LINE	QUANTITY	UOP	CAT NO.	ITEM NUMBER	UNIT PRICE	AMOUNT
***** ADDENDUM NO. 2 *****						
THIS ADDENDUM IS ISSUED TO:						
1) PROVIDE A COPY OF THE NON-MANDATORY PRE-BID SIGN IN SHEET.						
2) EXTEND THE DEADLINE FOR TECHNICAL QUESTIONS TO: 02/02/2012 AT 4:00 PM.						
3) TO EXTEND THE BID OPENING DATE AND TIME TO: 02/16/2012 AT 1:30 PM						
4) ADD THE FOLLOWING REQUIREMENT FOR GENERAL LIABILITY INSURANCE.						
(XX) INSURANCE: SUCCESSFUL VENDOR SHALL FURNISH PROOF OF COMMERCIAL GENERAL LIABILITY INSURANCE PRIOR TO ISSUANCE OF CONTRACT. UNLESS OTHERWISE SPECIFIED IN THE BID DOCUMENTS, THE MINIMUM AMOUNT OF INSURANCE COVERAGE REQUIRED IS \$250,000.						
5) PROVIDE THE ATTACHED PRE-BID MEETING MINUTES.						
6) PROVIDE THE ATTACHED REVISED PROCEEDURE DOCUMENTS.						
7) PRIVIDE THE ATTACHED REVISED PRICING PAGE.						
***** END ADDENDUM NO. 2 *****

Canaan Valley Resort State Park
DIVISION OF NATURAL RESOURCES

Contract 2A - Well Rehabilitation
REVISED FORM OF PROPOSAL-1

Contract 2A – Well Rehabilitation

JOB NUMBER:	11022
SCALE:	1" = 100'
DATE:	OCTOBER 2011
DRAWN BY:	FLB
DESIGNED BY:	RDD
CHECKED BY:	JEB
SHEET NO.	1

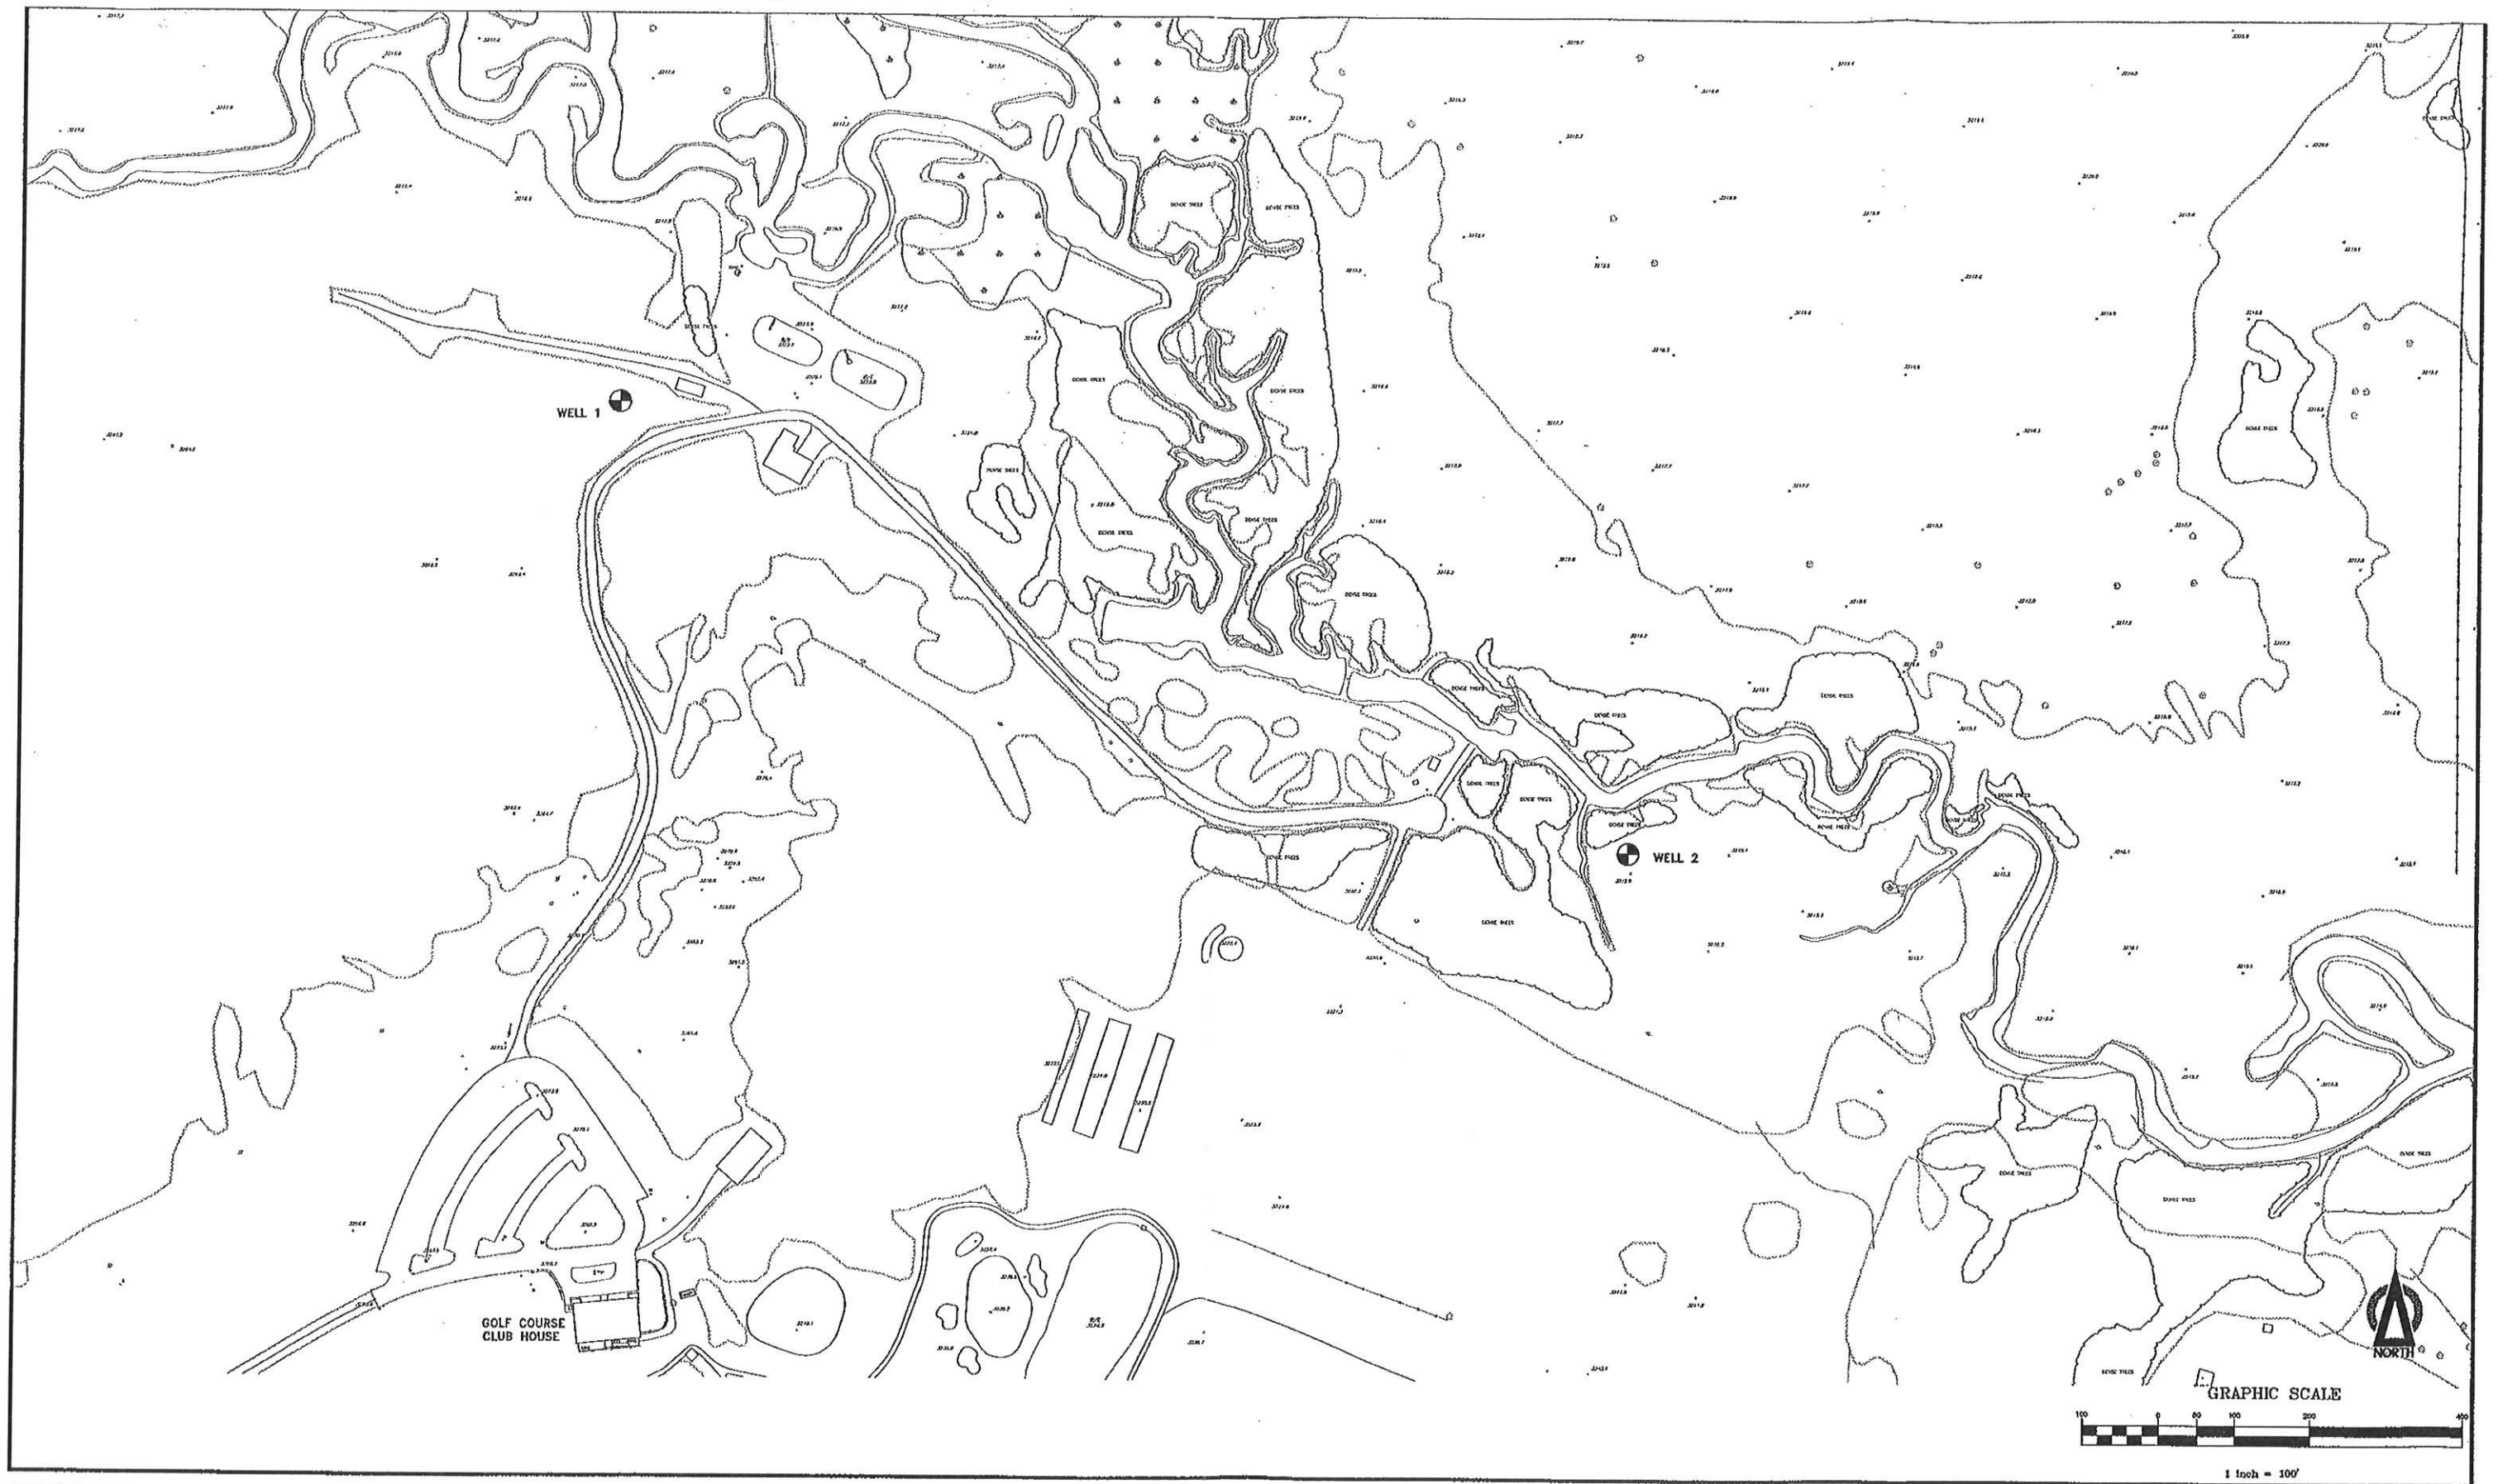
- Well location: The two production wells are located on a project map. Based on discussion and field observation it was determined that the location of Well No. 1 on the map is incorrect. The correct location of Well No. 1 is approximately 150 feet SE of the Water Plant Building. The location is accessible.
